Secretary  
Department of Planning and Environment  
GPO Box 39  
Sydney NSW 2001

## **Feedback on proposed Rankin Park to Jesmond - Newcastle Inner City Bypass project - EIS.**

I wish to provide the following feedback on the proposed Rankin Park to Jesmond - Newcastle Inner City Bypass project.

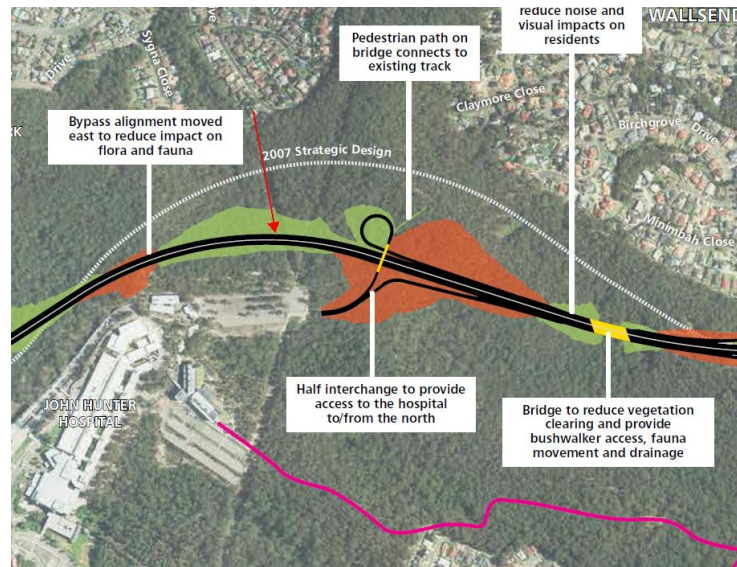
- An additional bridge / underpass structure in the vicinity of the red arrow (pictured below) would further facilitate access to the bushland for wildlife, recreational,

commuting and maintenance purposes.

Figure 9 - Alternate design - Route for Jesmond Cycleway

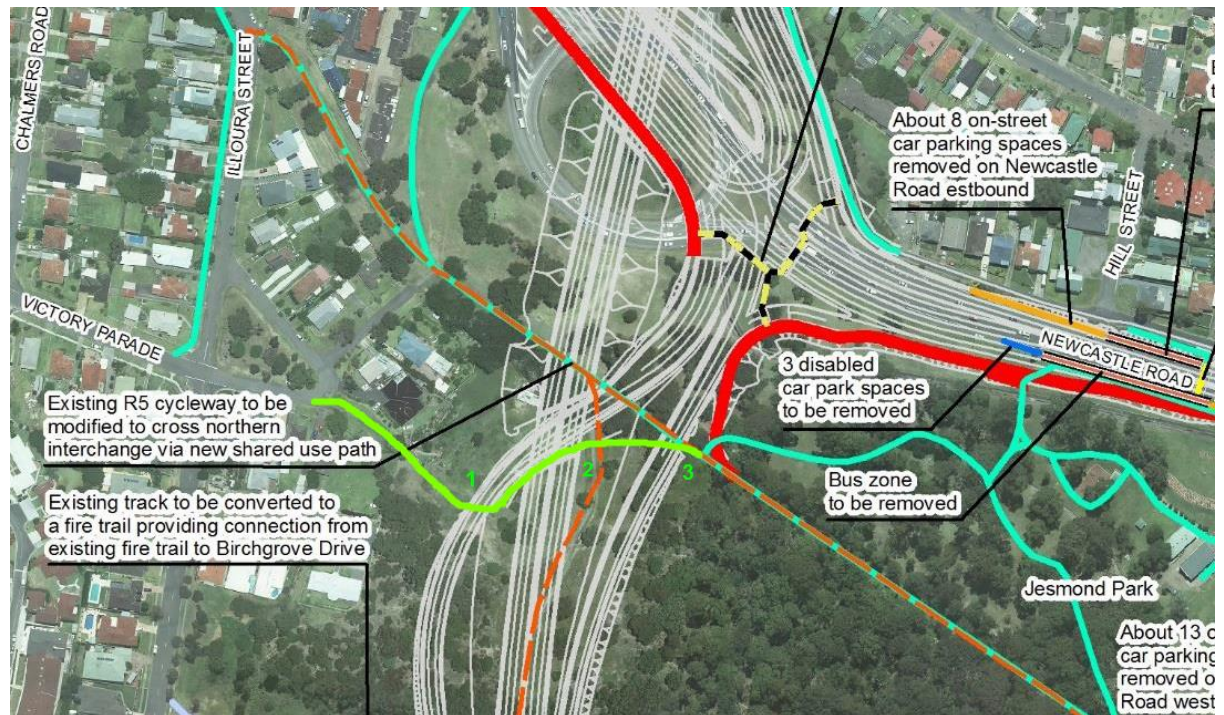
- Provision for cycling and pedestrian traffic on the Jesmond Cycleway – The proposal for cutting the existing route and replacing it with a route requiring three separate unsynchronised traffic control light crossings is unsatisfactory and dangerous. Requiring cyclists and pedestrians to this difficult route to cross the interchange will foreseeably cause commuters to cross against the traffic control signals proposed and will inevitably lead to collision incidents between cyclists, pedestrians and motor vehicles. This aspect of the design is very poorly conceived and does not correlate with the Newcastle City Cycleway plan. The proposed design is unacceptable and objectionable.

A better design is required for this interchange for cycle and pedestrian traffic that expedites movement without endangering commuters. This design should incorporate bridges and underpasses for the unimpeded flow of cycle and pedestrian traffic in an East/West direction from the existing Jesmond Cycleway.

Please consider the following proposed design for this traffic which utilises an existing easement between properties on Victory Parade to connect Jesmond Cycleway traffic to an already designated cycle route on Victory Parade. This route separates cycle and pedestrian traffic from the complex series of road crossings and provides the opportunity to build tunnels or bridges to keep this traffic separate. This eliminates the risk of cycle/pedestrian and vehicle collisions incidents and serves to encourage rather than discourage cycling as a means of transport. The key feature of this design is to link the Jesmond Cycleway with the Victory Parade cycle infrastructure without road crossings. This is achieved by using the available open space and topology to underpass the two tributary roads shown at 1 and 3 on the below diagram and to use the designed overpass at 2 on the diagram.

This design uses an existing easement between properties to route cycle traffic to Victory Parade and integrates with the cycling infrastructure provided by Newcastle City Council which extends along Victory Parade to Brickworks Park and to Newcastle Road.

The advantage of this design is the separation of pedestrian and cycle traffic from heavily trafficked roads and the elimination of the traffic light crossings in the proposed design which cause avoidable delays for motorists, cyclists and pedestrians alike. By utilising short tunnels under the new roads and the bridge already specified in the proposal, this design

should be achievable without significant additional cost or complexity.
